******* IMPORTANT VEHICLE RECALL NOTICE *******
RECALL REPAIR REQUIRED PRIOR TO CUSTOMER DELIVERY

RE: Volvo Recall 241
Certain Model Year 2011 S40 & C30 Vehicles

RTJ Instruction

No.24496

Side member inspection.

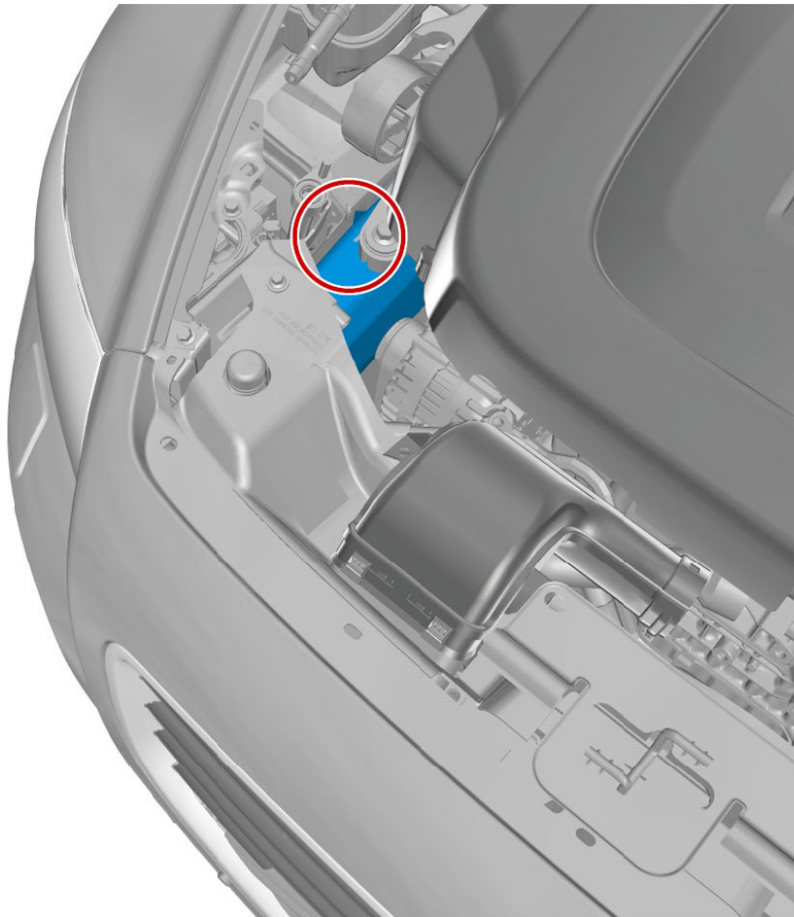
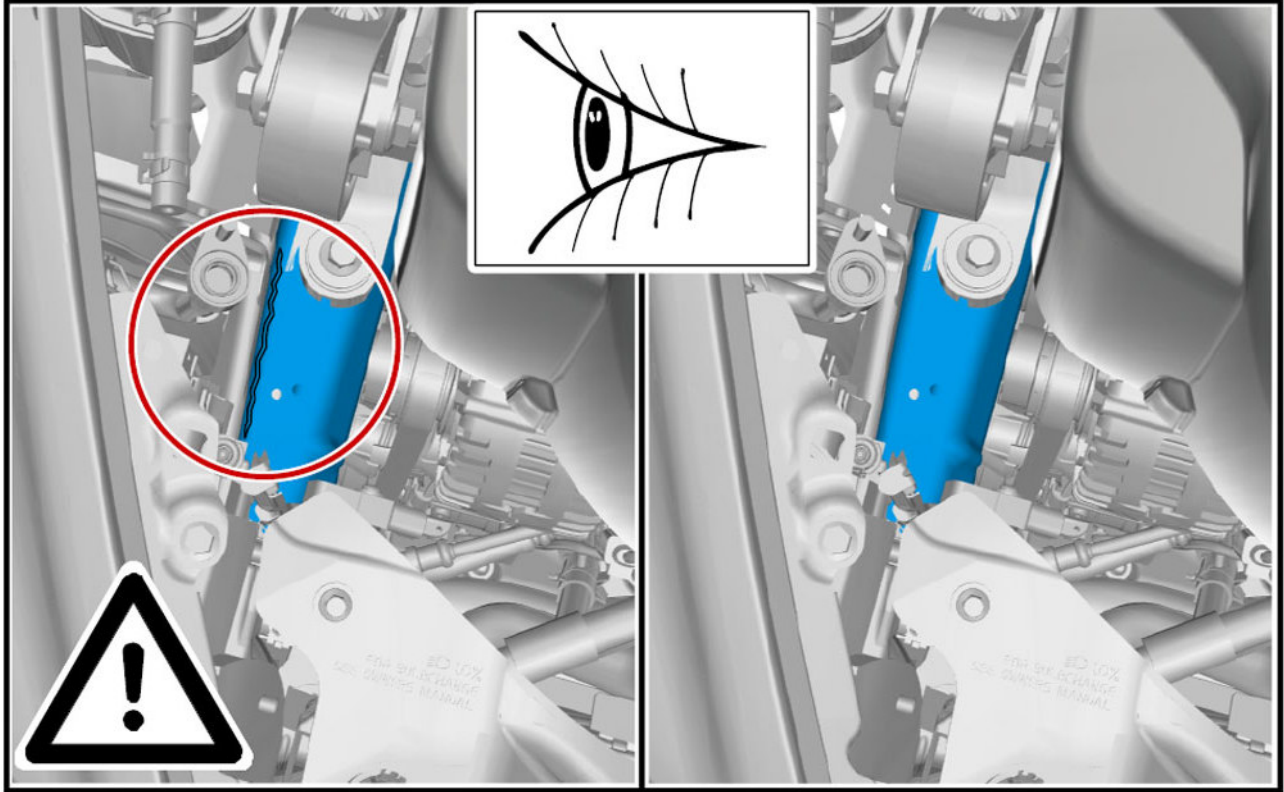
Check for cracks

NOT OK

OK

The corrective action is to inspect for a crack on the top side of the passenger side support member in the engine compartment per RTJ 24496.

If no crack is found, return the vehicle to the customer. This defect is the result of a component forming process issue in production, and there is no risk of a crack forming in the future.

If the inspection reveals that the vehicle has a crack in the side support member, the vehicle must be taken out of service immediately. Please have the Service Manager contact Volvo Fleet Customer Care at 1-877-283-5338. A new replacement vehicle of equal specification will be provided by Volvo.
